Address:	31 Daleham Gardens London NW3 5BU		<b>3</b>
Application Number(s):	2023/4241/P	<b>Officer:</b> Josh Lawlor	
Ward:	Belsize		
Date Received:	05/10/2023		
Proposal:	Erection of six-storey building providing 14 flats and associated landscaping, bin and bike stores.		
<p>Background Papers, Supporting Documents and Drawing Numbers:</p> <p>Existing Drawings:</p> <p>PL_E_010_PP1, PL_E_201_PP1</p> <p>Proposed Drawings:</p> <p>PL_L_100_PP2, PL_D_6100_PP1, PL_D_6101_PP1, PL_A_999_PP2, PL_A_1000_PP2, PL_A_1001_PP2, PL_A_1002_PP2, PL_A_1003_PP2, PL_A_1004_PP1, PL_A_1005_PP1, PL_A_2000_PP1, PL_A_2001_PP1, PL_A_3000_PP1, PL_A_3001_PP1, PL_A_3002_PP2, PL_A_3003_PP1, PL_A_3010_PP1, PL_C_4000_PP1, PL_L_500_PP2, SMW-XX-XX-DR-C-001-S3-P4.</p> <p>Documents:</p> <p>Daylight and Sunlight Report dated September 2023, Flood Risk assessment S221215-SUB-99-XX-FRA-C-00001 April 2023, Structural and Drainage Report Stage 3 dated May 2023, Basement Impact Assessment dated 28.04.2023, Noise Report BD/CS/P23-2822/01 Rev A dated March 2023, MEP Report dated April 2023, Overheating Assessment MB/VL/P23-2822/04 Rev B, Preliminary Arboricultural Impact Assessment Ref. SHA 1198 Dated September 2021, Air Quali

*Figure 5 - Solar shading images for Spring Equinox (21 March) at 10.45*

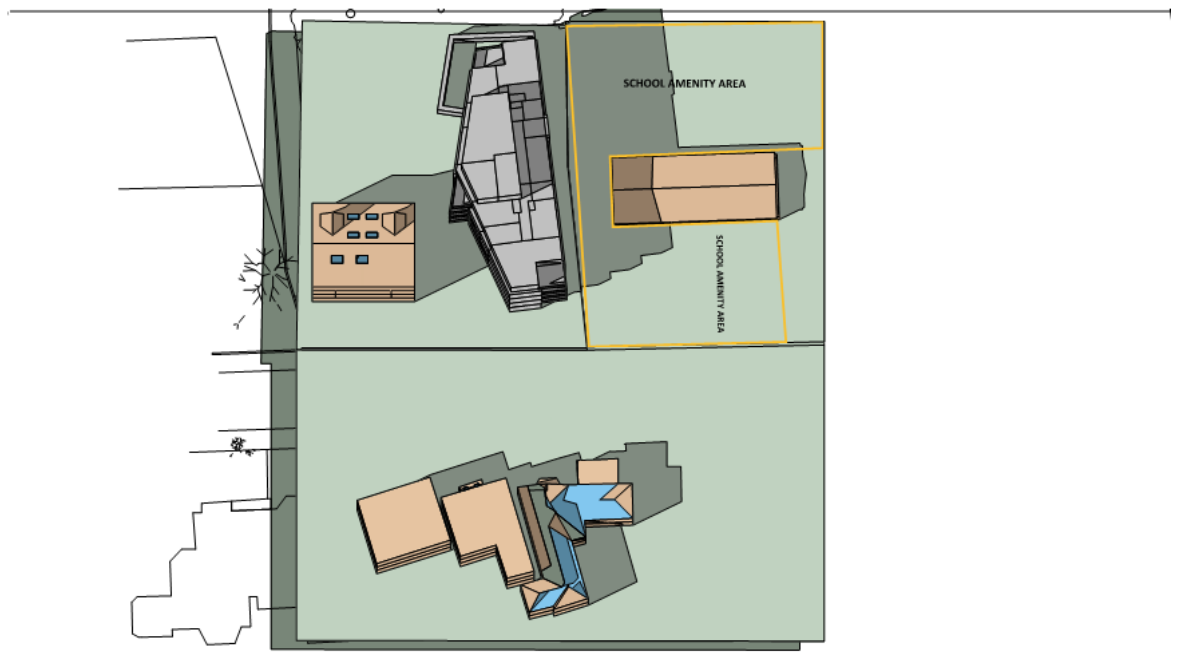
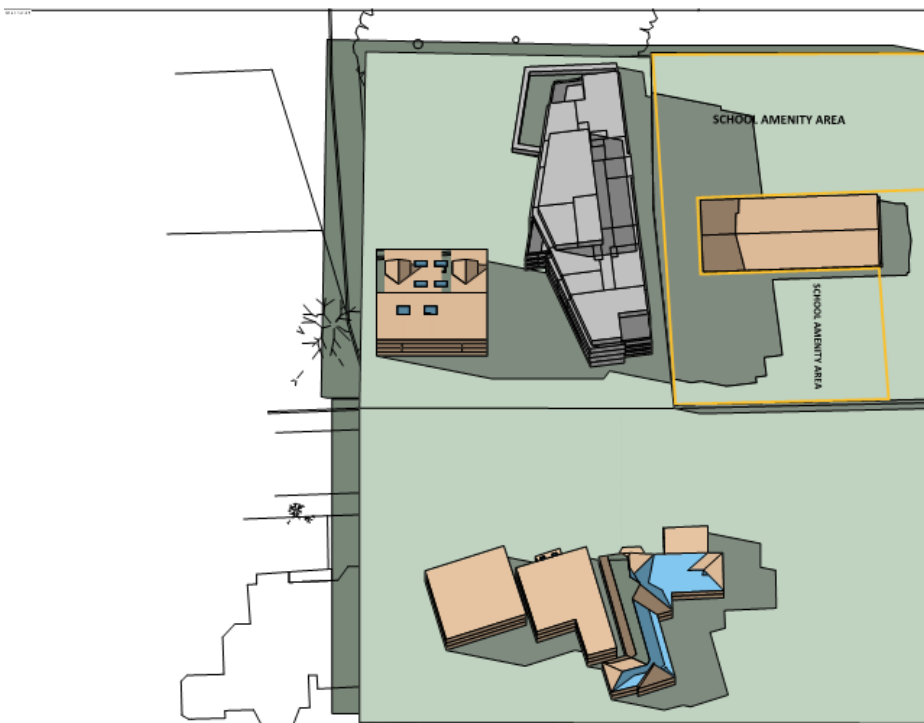
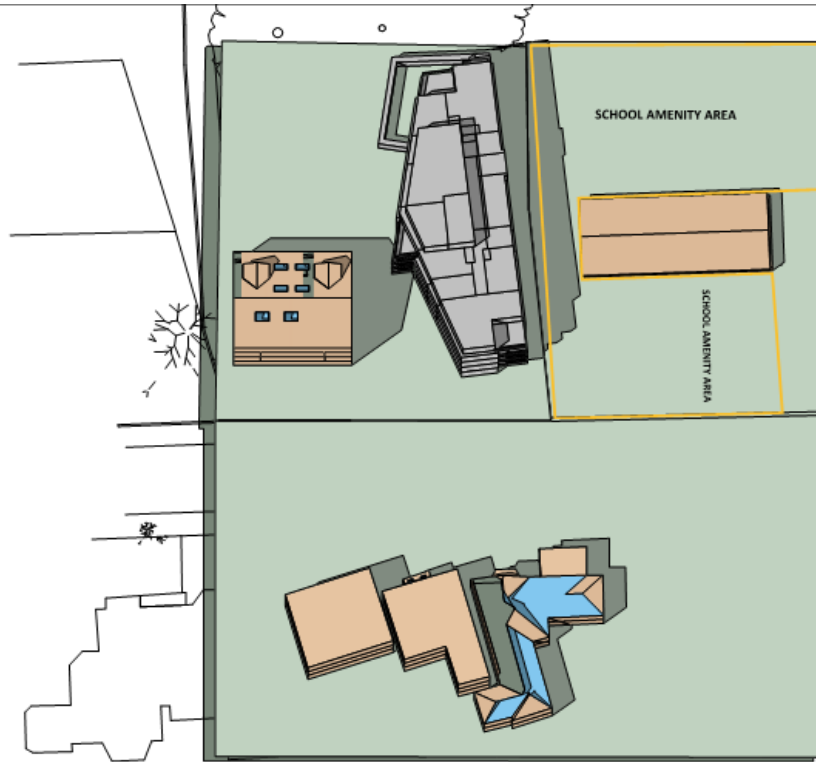
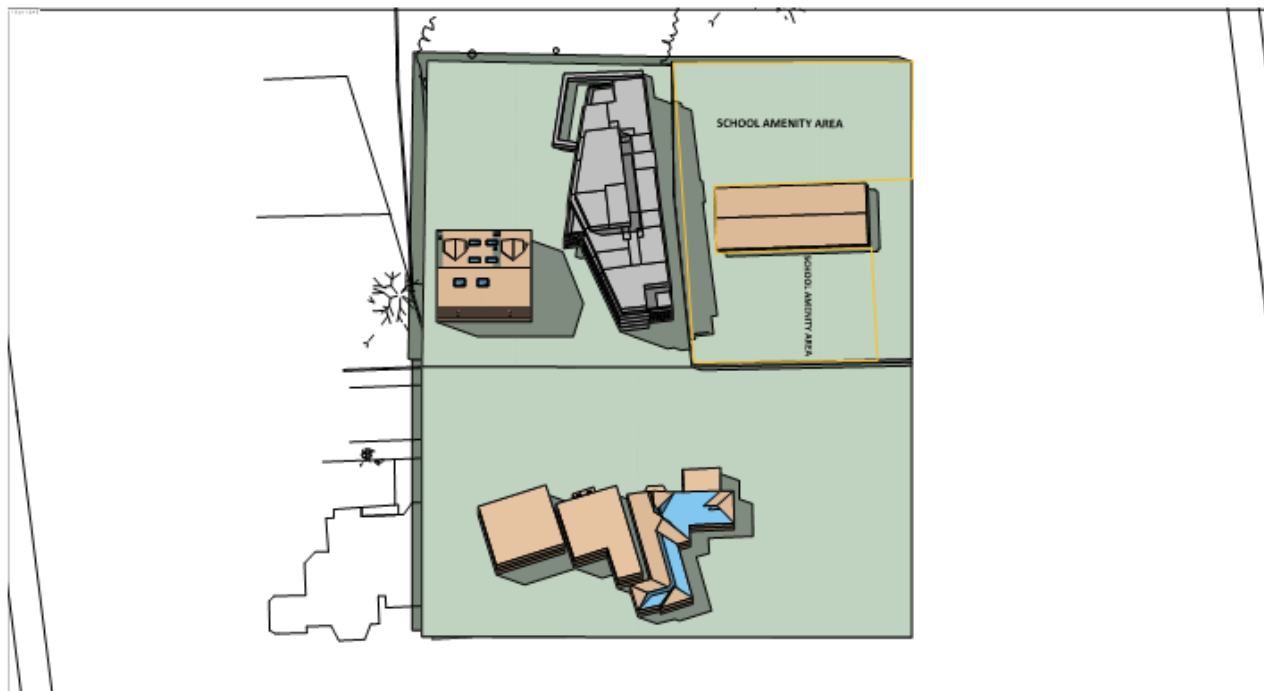
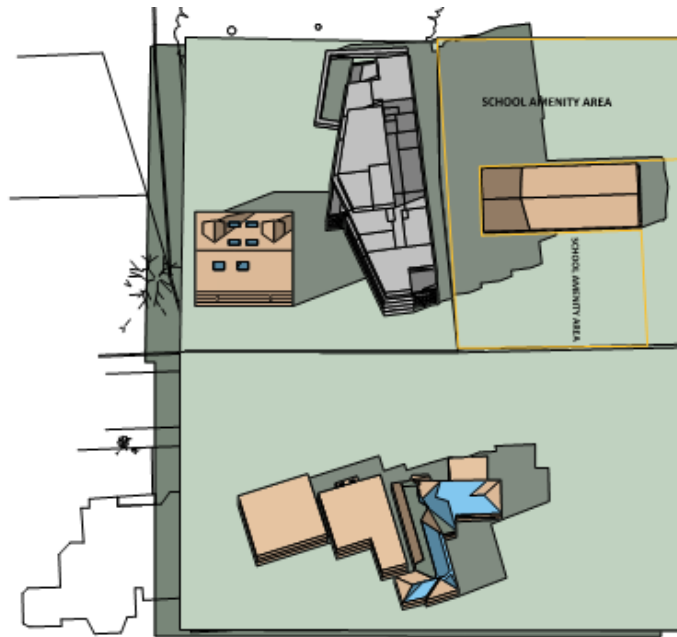
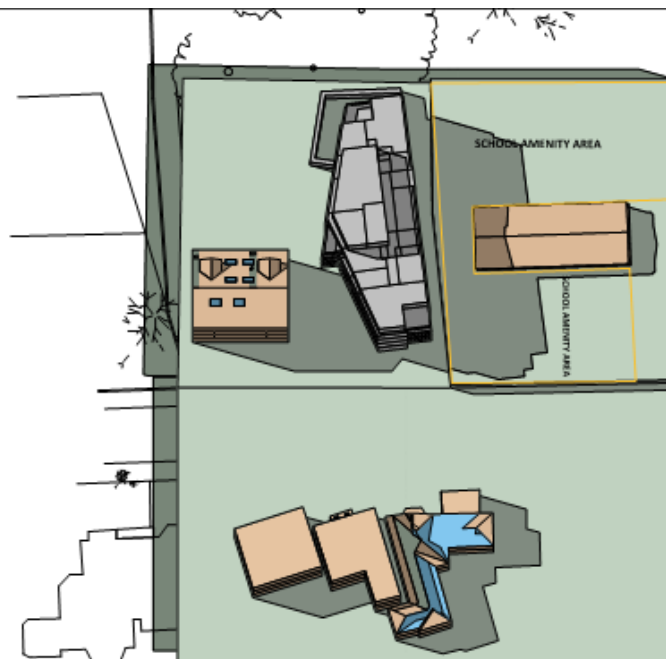
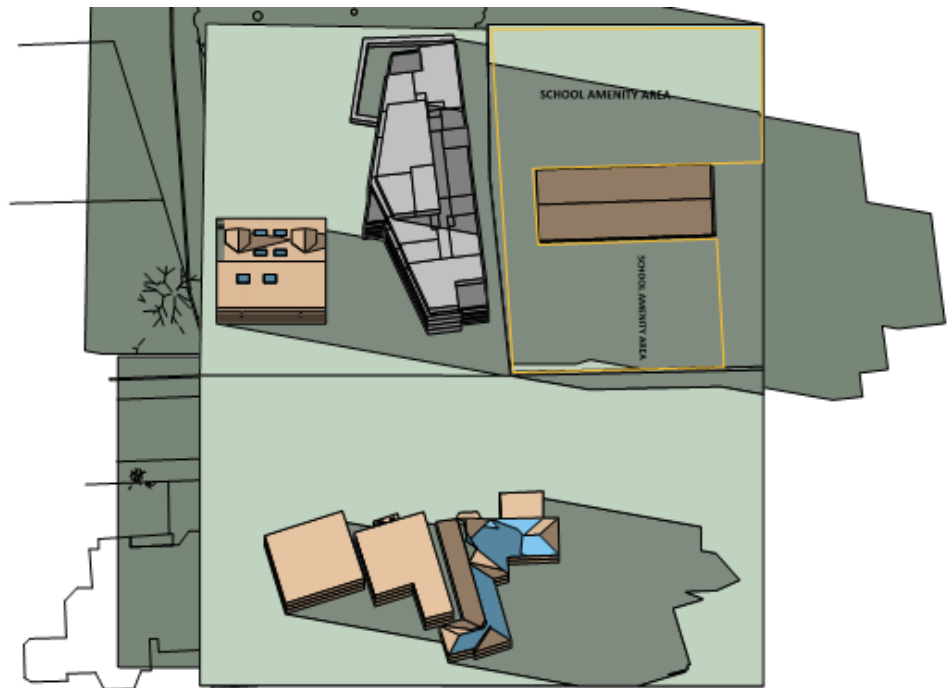
- The shading images shown in Appendix F of the Daylight Report show the roof shadow as regular and straight-edged, but the building has a staggered height so the shadow should be irregular

*A concern has been raised that the shadow diagrams are inaccurate as they appear to show a flat-topped building whereas the proposals have a partial 6th storey in the centre of the building. The applicant have checked the model and confirmed that this has been modelled correctly – the top floor is set back approximately 3.5m from the main external wall and so its shadow does not project out further than the lower floors at the equinox. At least half of the amenity area will receive at least two hours of sunlight on the 21st of March. The LPA see no reason to deviate from BRE guidance or impose stricter tests. The assessment was updated to include the whole external area. The shading images in Appendix F of the Daylight Report show the shadow correctly and illustrate compliance with BRE guidelines.*

Figure 13 – Extract of the north elevation showing the obscure glazed windows in yellow with only bedroom windows and high level windows with clear glass

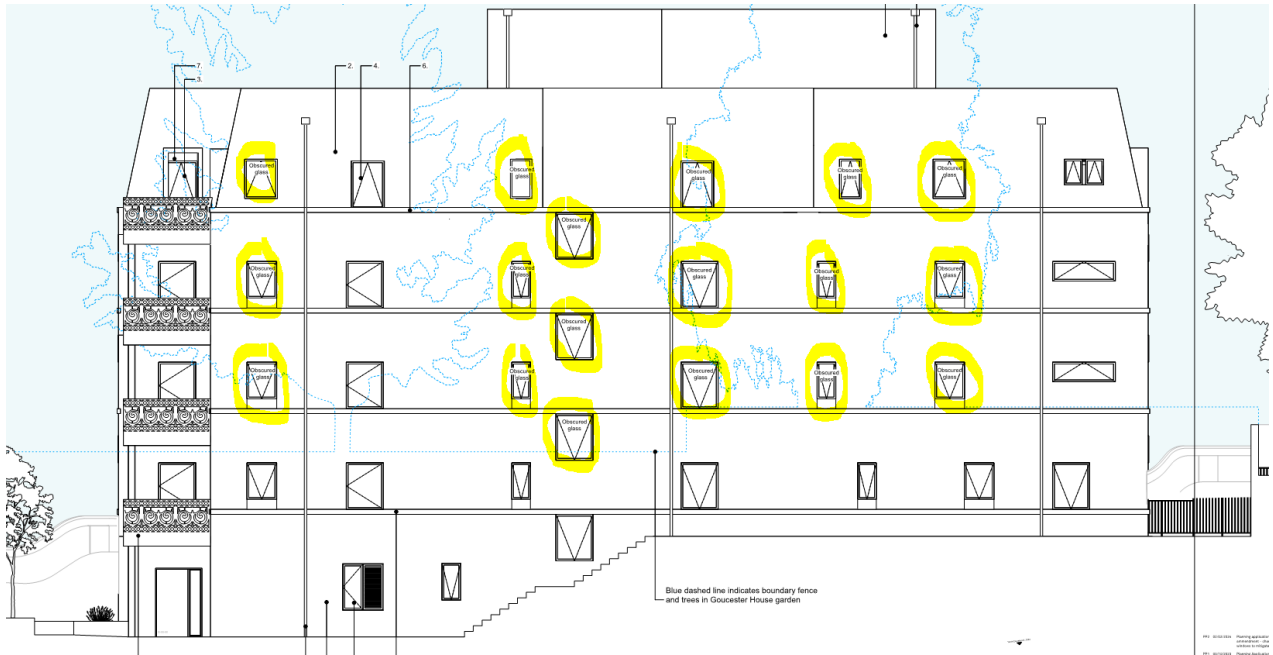
- 11.19 Despite mitigation measures, there could be perceived overlooking into the school and playground areas which could impact on the children, some of whom may suffer from greater sensitivity to this because of disability (a protected characteristic).

- 11.18 The northern elevation of the proposed building will comprise smaller windows serving bedrooms, bathrooms and kitchens, most of which will be obscure glazed and bottom hung, to create a reduced impact on overlooking to Gloucester House School playground to the rear. There would also be balconies on the front elevation but would only allow oblique views into the front area of the school. There is substantial existing screening within the Gloucester House School site, comprising mature trees, which will not be impacted by development. Officers have sought additional changes in the design to further mitigate this impact, including cill levels and obscure glazing. All windows are obscure glazed other than bedroom windows (only 3 above ground floor) and the others are high level windows (3 above ground floor) which only provide light and not outlook. See Figures 13 and 14 for the arrangement of obscure glazed windows the north elevation and the plans showing the use of the rooms.

*Figure 17 – Details of balustrade to be secured by condition*

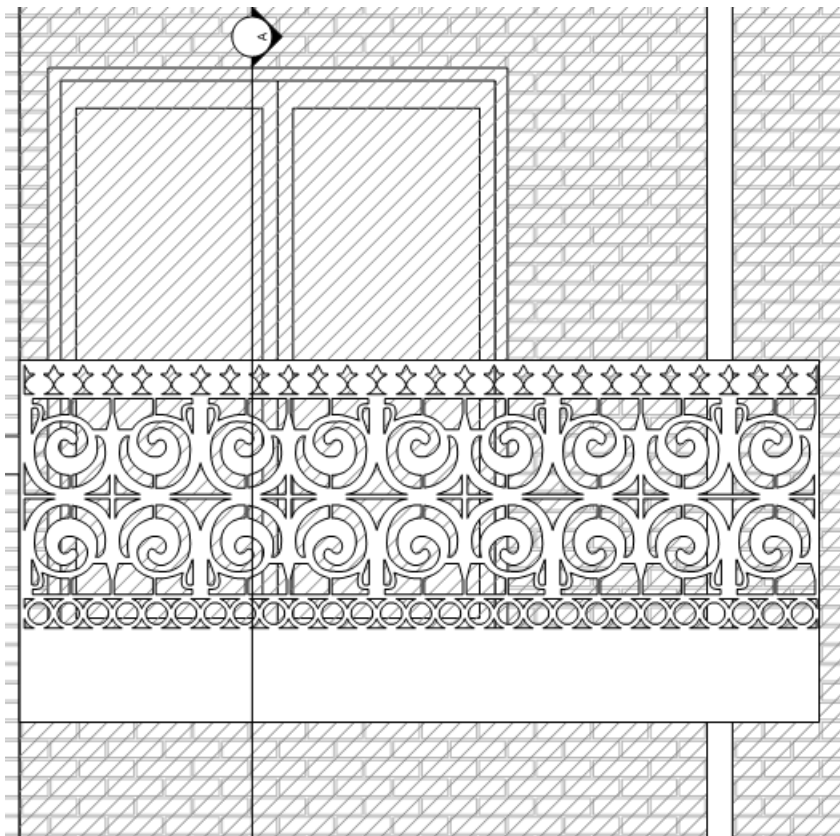
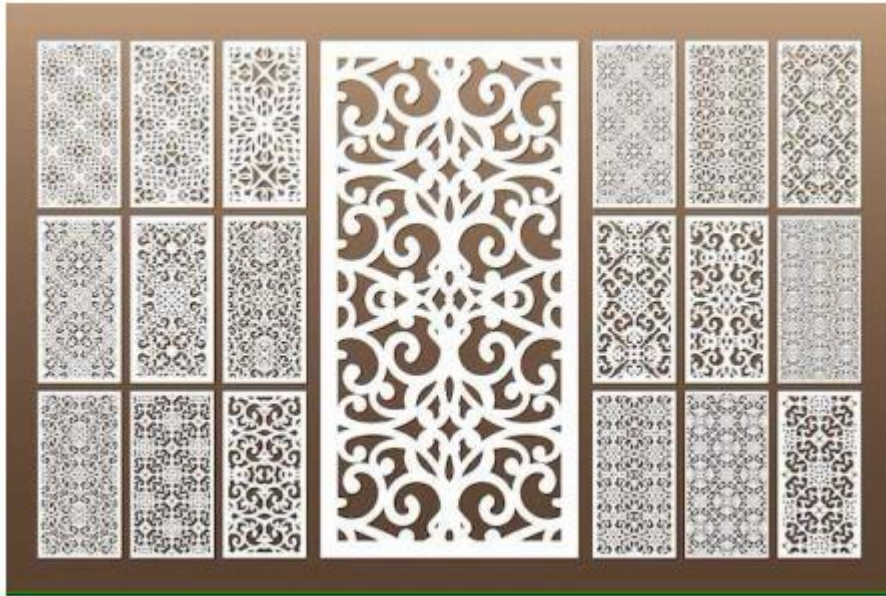
**Balconies:** *The design includes balconies, and while there may not be a precedent for balconies facing the street in the area, the inclusion is intended to provide outdoor space and enhance the quality of living for residents.*

- 12.16 The above images show local details. The white window surrounds, and decorative balustrades were derived from the houses on Daleham Gardens. The pattern shown on the proposed drawings including the balcony detail drawing is only indicative and will be fully designed working with a fabricator during the technical design process with details secured by condition 5.
